RE: Addendum No. 2 – Fort Bend County RFP 21-078 Construction of Linear Jail Renovation in Fort Bend County

PROJECT NAME: Fort Bend County - Jail maintenance repairs and renovations

PROJECT NUMBER: RFP – 21-078

ADDENDUM DATE: Thursday, May 13, 2021

SHEET NO.
A1-05

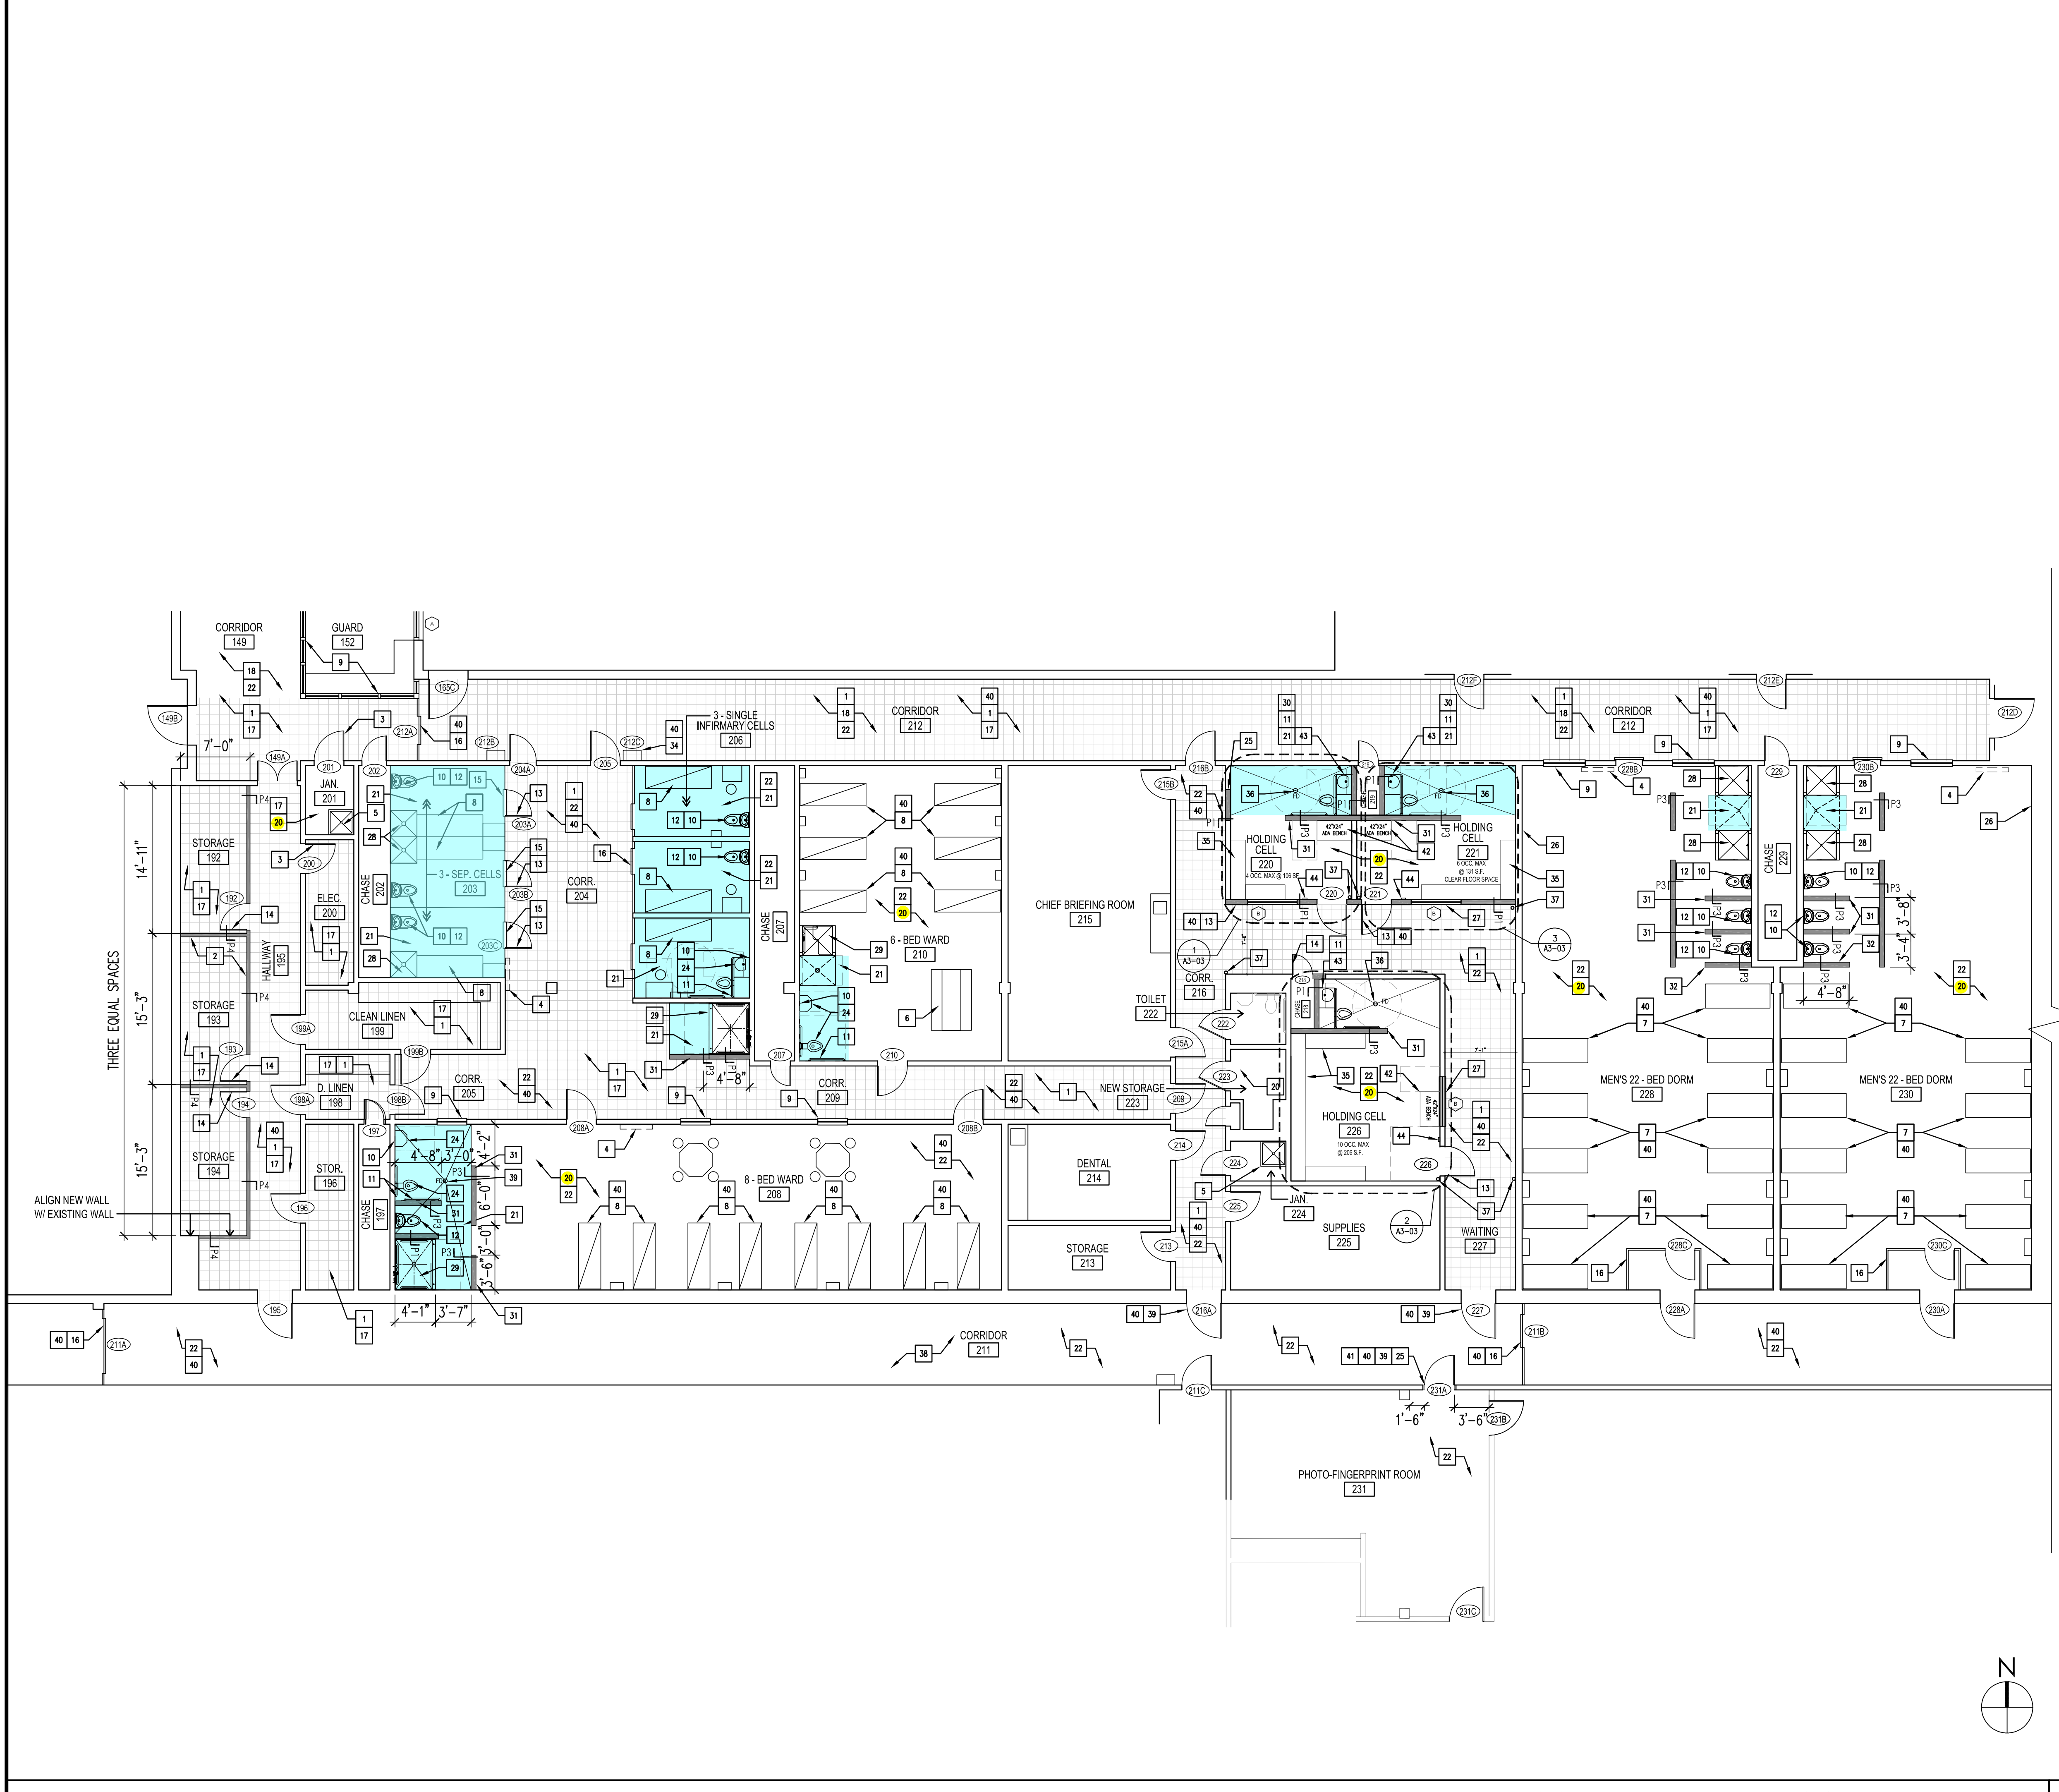
1. There doesn't appear to be a finish schedule or the call out for epoxy in the plans. Please advise.

3. The Scope of Work is specified on sheet A0-30 section 09 67 26 Quartz Flooring. The specification gives reference to Torginol Quartz Blend but does not reference any manufacturers or more importantly the thickness of desired flooring system. Please clarify any manufacturers or thickness for the Quartz Flooring.

[STOA](#): Epoxy is called out on the plans on sheet A1-01, A1-03, and A1-05. (Outlined areas indicated as Keynote 1, 20, and 21.) Refer to the legend indicates the epoxy quartz shown as:

STOA: 40-S grade Quartz floor epoxy is used for lighter duty systems at 1/8" thickness. Epoxy is called out on the plans on sheet A1-01, A1-03, and A1-05. (Outlined areas indicated as Keynote 1, 20, and 21.) Refer to the legend indicates the epoxy quartz shown as:

System No. W-L-1479

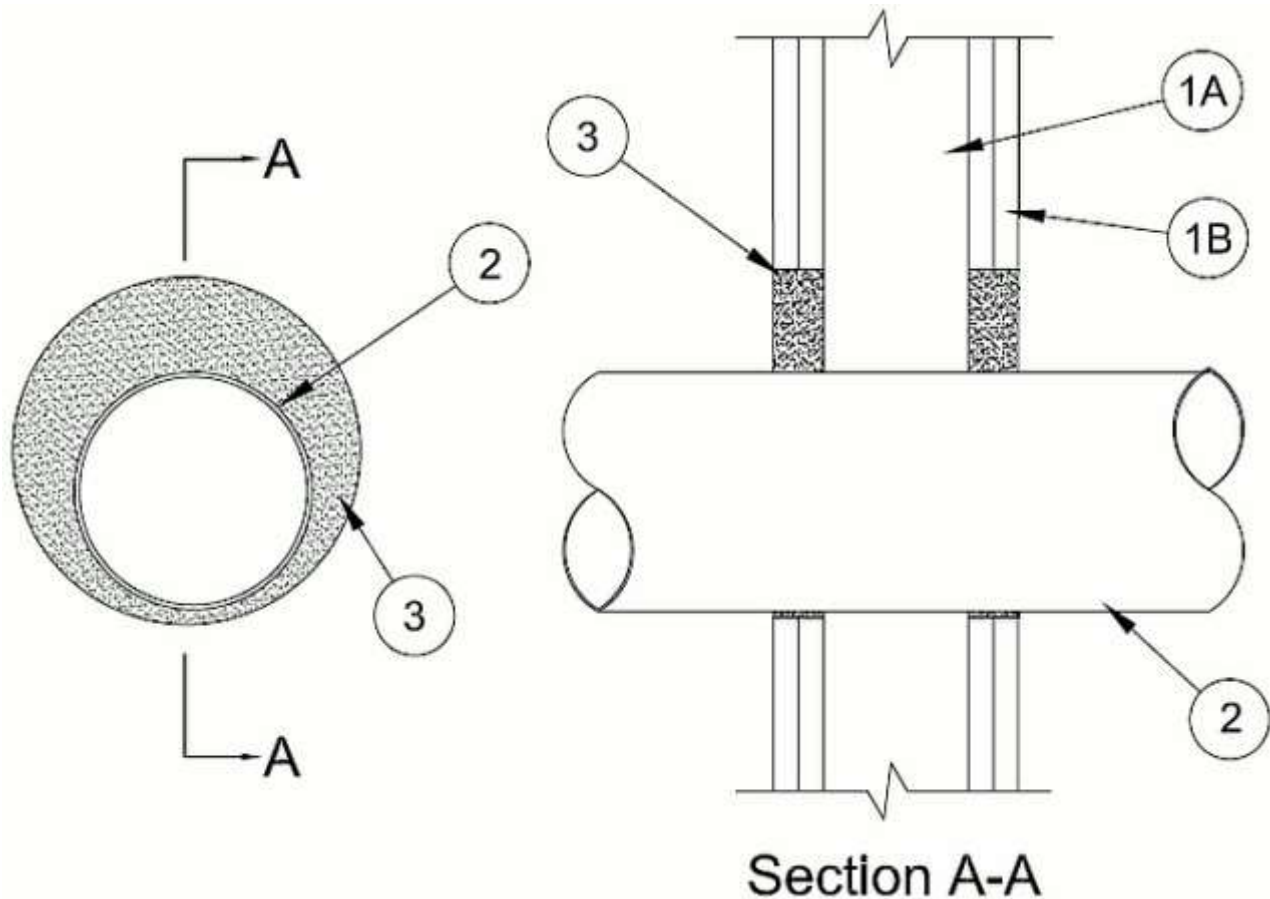
21. Spec Section 078400 Firestopping. Please indicate where this would apply as there are no mention of fire rated walls other than the corridor on south side on building F.

STOA: It generally applies at any typical through-penetration that would be affected thought the project scope of work. See attached UL system no. W-L-1479 for additional information.
